STATEMENT OF RESPONSE TO AN BORD PLEANÁLA PRE-APPLICATION CONSULTATION OPINION

**Proposed Strategic Housing Development
Lands at Back Road & Kinsealy Lane,
Kinsaley, Broomfield, Malahide, Co. Dublin**

Applicant: Birchwell Developments Ltd.

April 2022

Figure 1. Fingal County Council Land Use Zoning Map, 2017-2023 (Lands outlined in red)

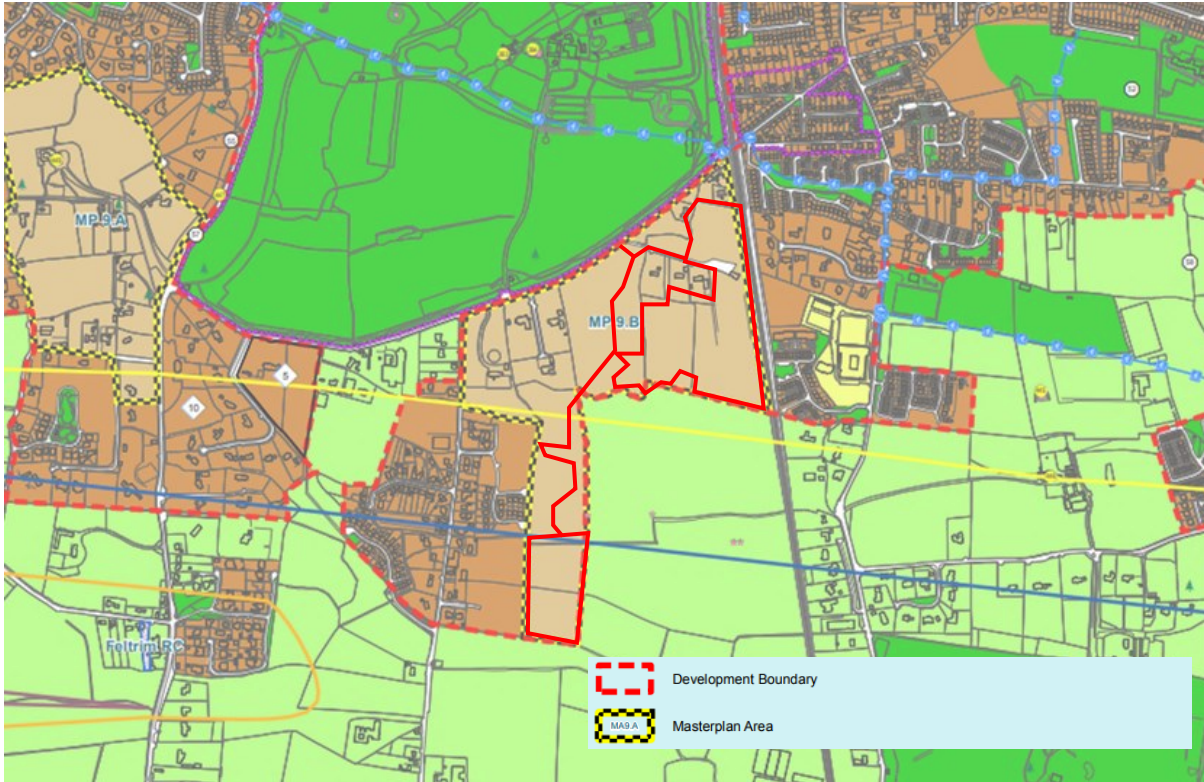
“Further consideration and/or elaboration of the documents in relation to core strategy and the zoning of the site, with a site layout plan overlaid on the zoning map.”

Under the Fingal County Council Development Plan 2017-2023, the subject site is zoned “RA - Residential Area” which seeks:

Therefore, it is submitted that the application site is located on appropriately zoned lands within the development boundary of Malahide, representing the completion of the overall development for the Broomfield lands. Moreover, the proposed development of residential units and 1 no. childcare facility

Figure 2. Dublin Airport Noise Zones extracted from the Development Plan (approximate boundaries of the subject site outlined in dashed black line)

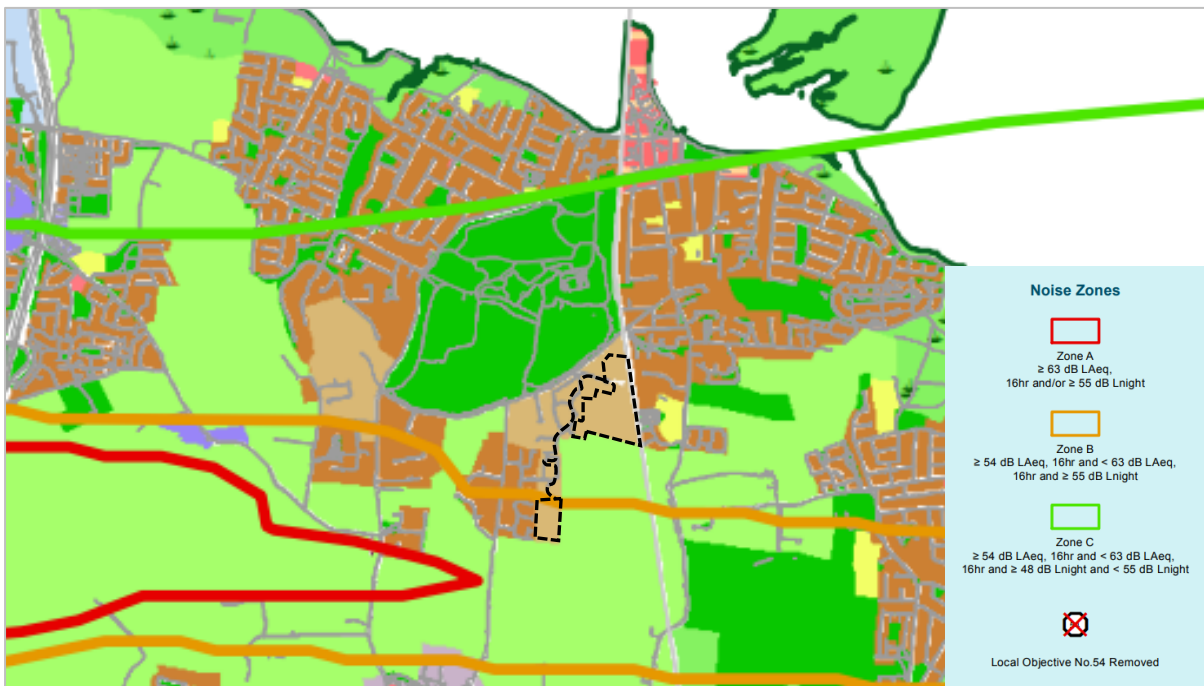
“Further consideration and/or elaboration in relation to all relevant objectives and guidance set out in the development plan addressing noise, specifically relating to airport noise and public safety zones.”

With respect to the Dublin Airport Noise Zones and as illustrated in the Figure below, the majority of the subject site is located within the Noise Zone C, and a small portion of the site in the southern ends is located in the Noise Zone B.

This Strategic Housing Development application is accompanied by a detailed noise assessment prepared by AWN Consulting Ltd. which is contained within the EIAR. This assessment demonstrates the proposed development is compliant with the relevant standards in the Fingal Development Plan Variation no. 1, and good acoustic design has been followed in the design process.
